Enclosure (1) is the Final Parcel E Nonstandard Data Gaps Investigation Landfill Lateral Extent Evaluation. This report is provided for your information.

Enclosure: 1. Final Parcel E Nonstandard Data Gaps Investigation Landfill Lateral Extent Evaluation, Hunters Point Shipyard, October 29, 2004

This document discusses data collected for, and results of, an investigation to assess the extent of solid waste at the Industrial Landfill in Installation Restoration Site 01/21 of Parcel E (hereinafter referred to as the Landfill) at Hunters Point Shipyard (HPS) in San Francisco, California. This work was conducted as part of the Parcel E nonstandard data gaps investigation under the protocols set forth in the "Draft Final Field Sampling Plan and Quality Assurance Project Plan [FSP/QAPP] for Parcel E Nonstandard Data Gaps Investigation (Industrial Landfill and Wetlands Delineation), HPS, San Francisco, California," dated January 8, 2002. This report is part of the revised remedial investigation and feasibility study for the Landfill at HPS. The results from this evaluation will be used to assist in development of the final remedy for the Landfill.

**FIGURE 7
 CROSS SECTION A-A'**

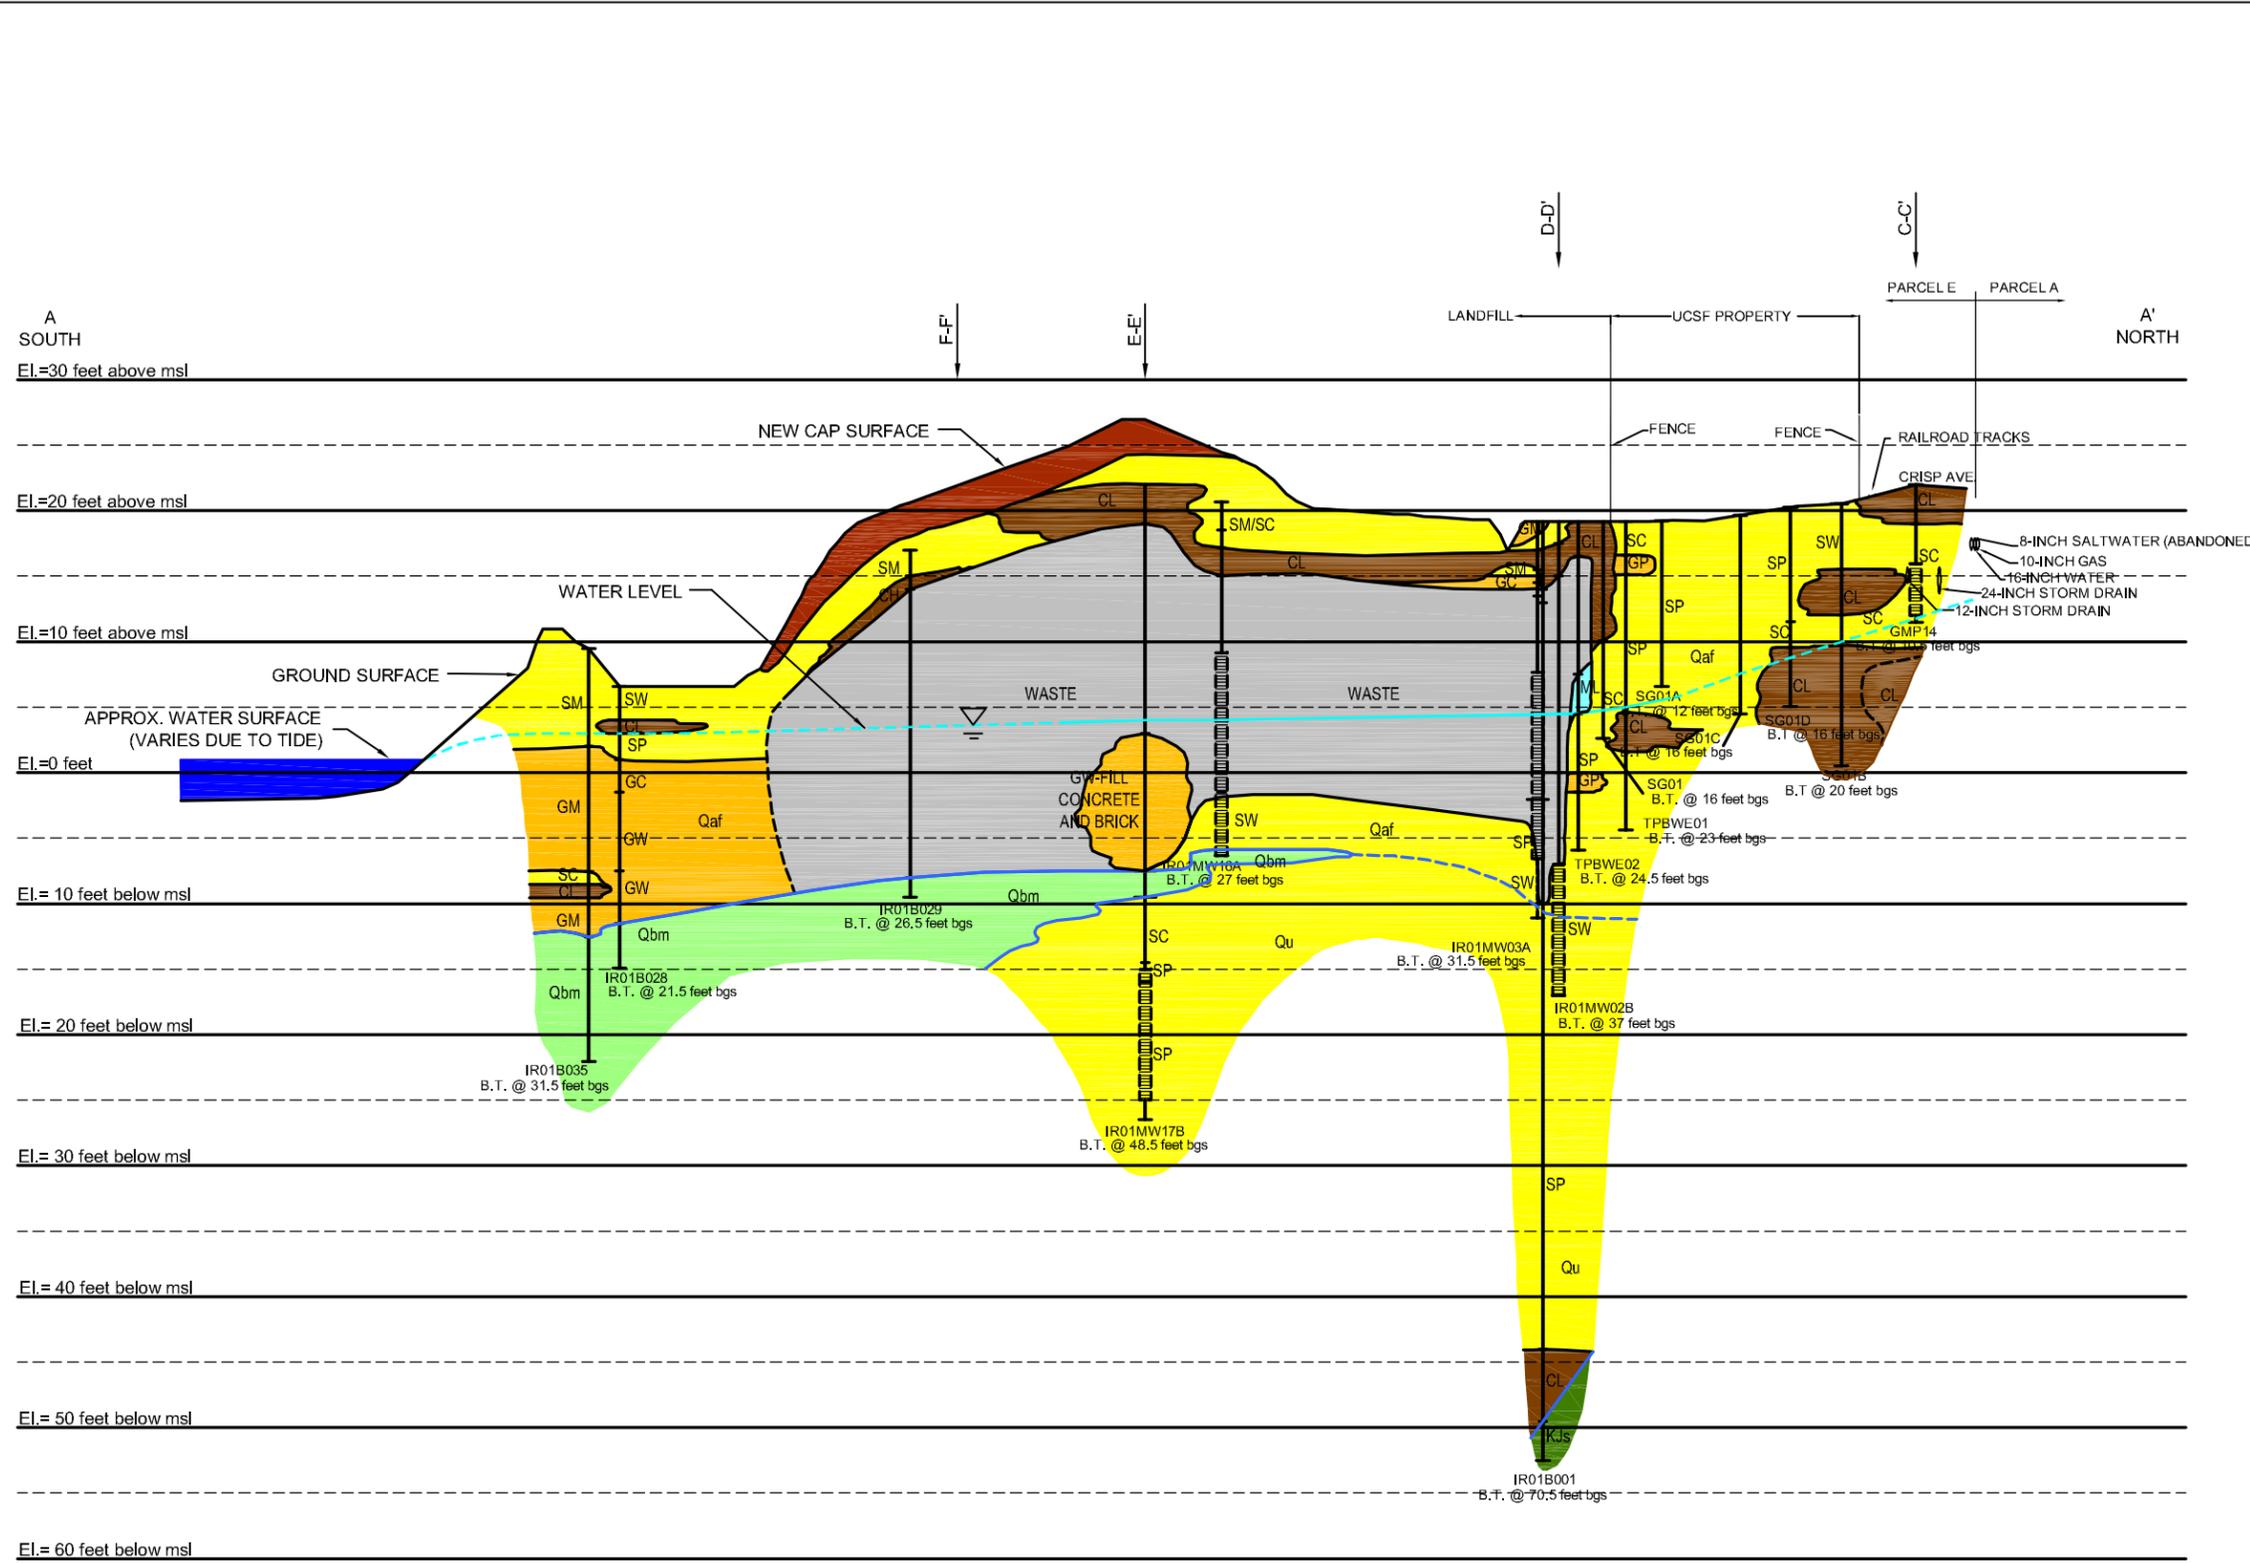
2. Comment: **Figures 7 through 12: It is unclear why solid lines were used to delineate the extent of lithologic units in areas where there is no data. It is standard industry practice to use dashed lines. For example, on Figure 7 the southern extent of waste is an abrupt vertical line, but the nearest borings are about 105 and 110 feet away and there are no test pits in this vicinity. Please revise the cross sections to use dashed lines where there is no lithologic data.**

3. Comment: **Figure 7, Cross Section A-A ': According to the boring log, the bottom 4 feet of the screened interval of IR01MW03A is poorly graded sand, but Figure 7 indicates that the poorly graded sand is below the screened interval. Please resolve this discrepancy.**

4. **Comment:** **Figure 7, Cross Section A-A ':** The log for boring SG01B indicates that the interval between 10.5 and 20 feet below ground surface (ft bgs) is clay with 10 per cent sand and occasional gravel, but the lithology on the cross-section is sand. Please resolve this discrepancy.

5. **Comment:** **Figure 7, Cross Section A-A' and Figure 10, Cross Section D-D':** According to the boring log, the sand just above the screened interval of IR01MW02B is black sand with wood. This may be sand blast grit, which is a waste rather than the non-waste sand symbol used on the log. It appears that this would correspond more closely with the depth waste was observed in adjacent boring IR01B001. Please revise the cross-section to indicate that waste extends to the depth of the top of the screen in the vicinity of IR01MW02B.

Response: The Navy has revised Figure 7 of the final report to show dashed lines to represent the southern extent of the waste. However, solid lines will continue to appear on cross sections based on lithologic, visual, or documented data used to establish the extent of the lithologic units.

Response: The Navy has revised [Figure 7](#) of the final report as requested. The length of the screened interval for well IR01MW03A was increased to be consistent with the well log.

Response: The Navy has revised [Figure 7](#) of the final report as requested. The interval between 10.5 to 20 feet bgs for boring SG01B was revised to indicate that the lithology is clay.

Response: Because of the presence of trace wire from 19.5 to 27 feet bgs as indicated in the log for well boring IR01MW02B and trace cloth debris from 23 to 27 feet bgs shown in the log for well boring IR01MW03A, the designation for these intervals was revised to indicate waste on [Figures 7 and 10](#).

**FIGURE 9
 CROSS SECTION C-C'**

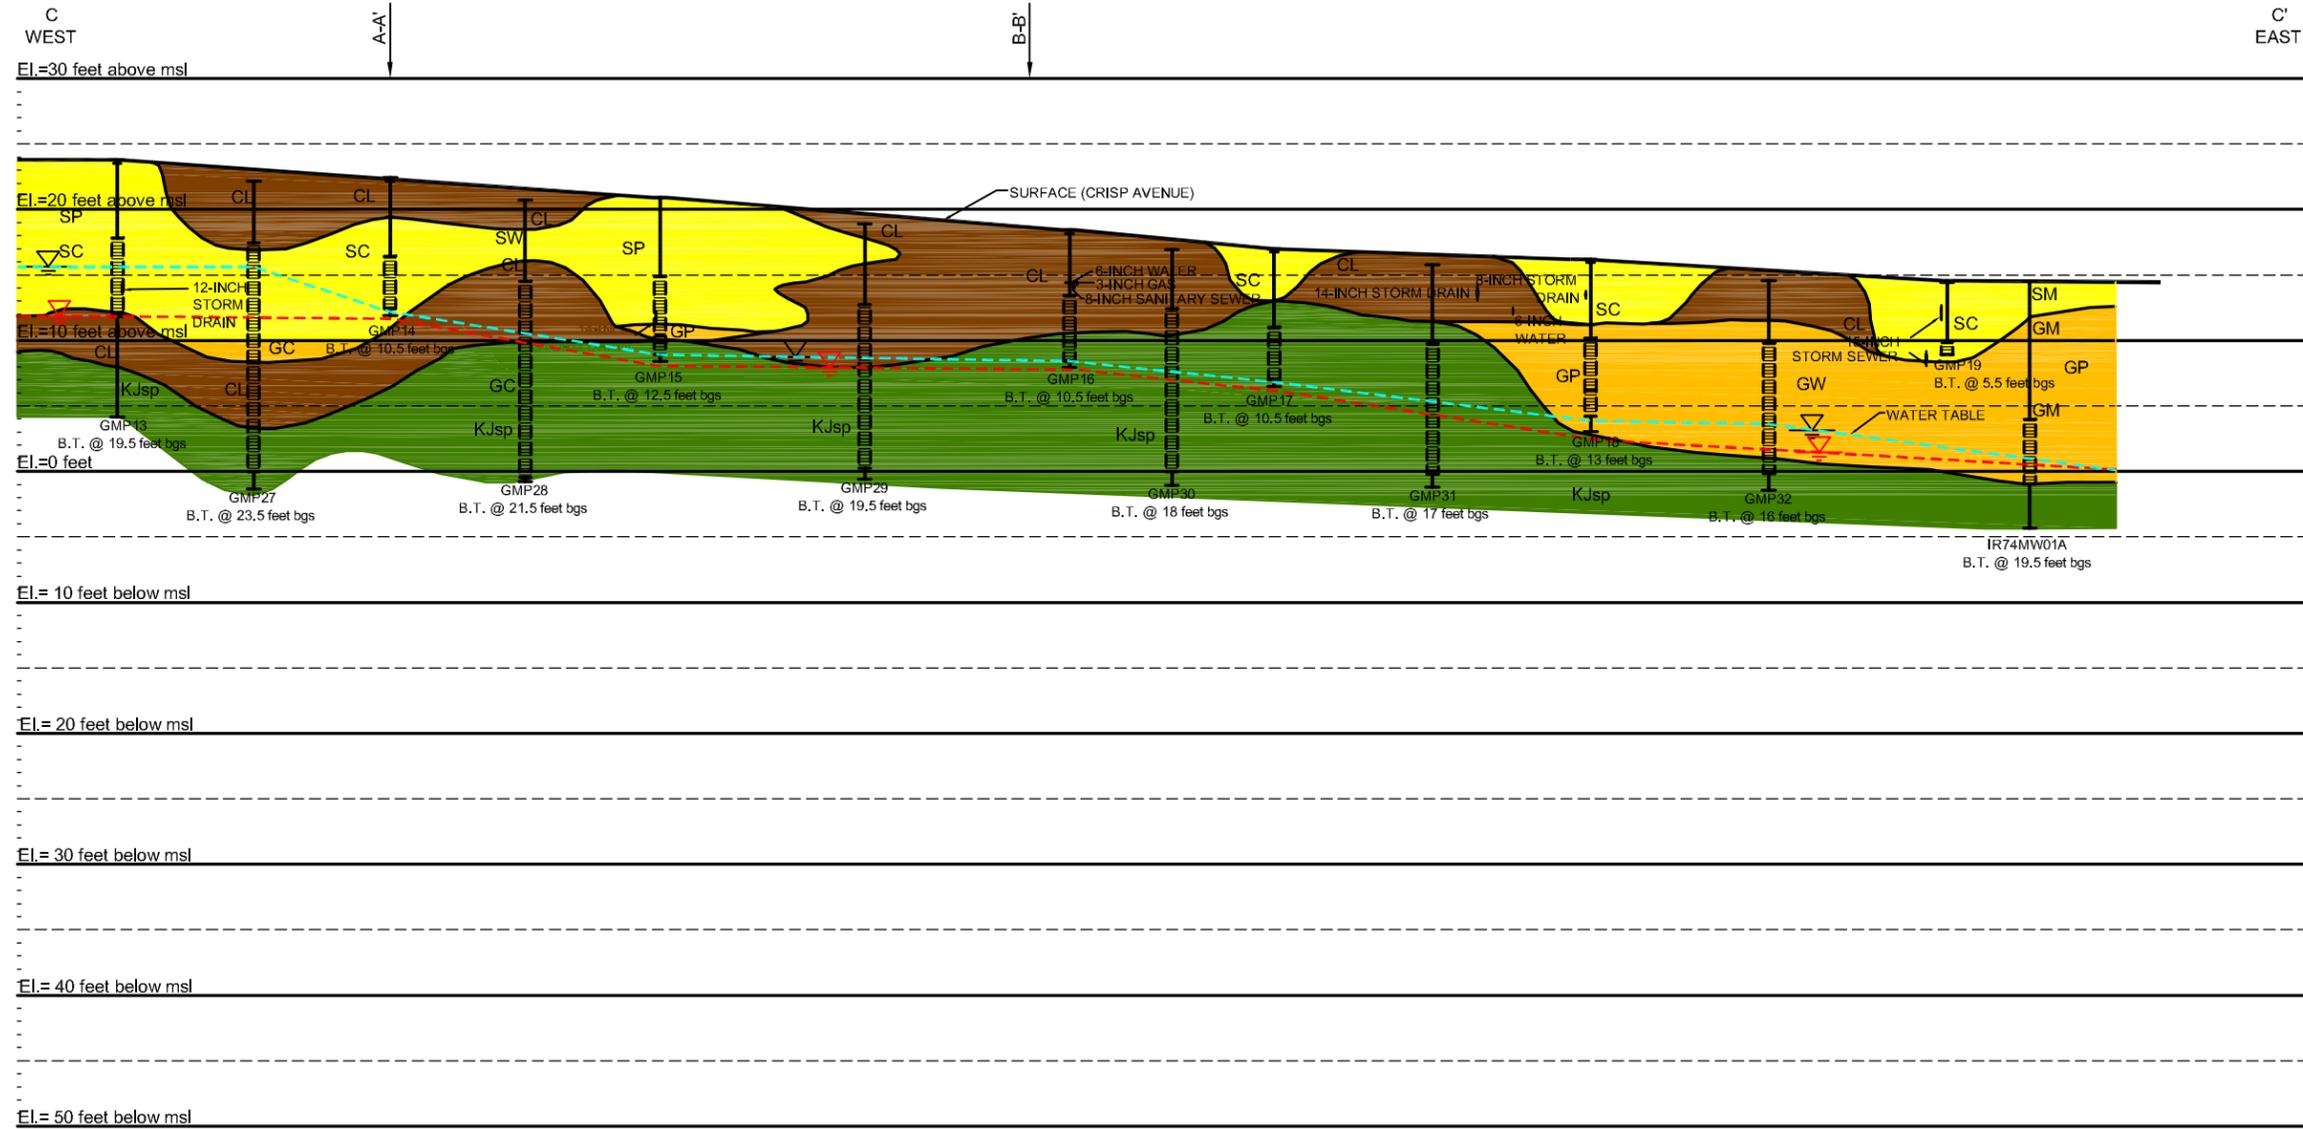
10. **Comment:** **Figure 9, Cross Section C-C': The log of boring GMP13 and the portrayal of this boring on the cross section may be inconsistent. The log indicates that the interval between 3 and 6 feet bgs is "CLAY and gravel," but this unit is classified with the lithologic label sc on the log and drawn as sand on the cross section. The classification on the log and the depiction as sand appear to be incorrect. Please resolve these discrepancies.**

11. **Comment:** Figure 9, Cross Section C-C': The log for boring GMP18 indicates that clayey sand extends from 0 to 5 ft bgs, but the thickness of this unit on the cross-section appears to be at least 8 feet. Please resolve this discrepancy.

Response: The Navy has revised boring log GMP13 in the landfill gas characterization report ([Tetra Tech 2003](#)) to be consistent with the lithology shown in the field log. [Figure 9](#) of the final landfill lateral extent evaluation report shows the correct lithology at boring GMP13. [Figure 9](#) therefore has not been revised in response to this comment.

- Response:** The Navy has revised Figure 9 of the final report to be consistent with boring log GMP18.
12. **Comment:** Figure 9, Cross Section C-C': There is little resemblance between the boring log for IR74MW01A and the depiction of the lithology in the vicinity of this boring on Cross Section C-C'. The cross section indicates that the lithology from 0 to 13 ft bgs is sand, then from 13-14.5 ft bgs, gravel, then below 14.5 feet, bedrock. The log for this boring indicates that sand only extends from the surface to 2.5 or 3 ft bgs, then gravel extends to 16 ft bgs, and bedrock is found below 16 ft bgs. Please revise the cross section to depict the correct lithology.
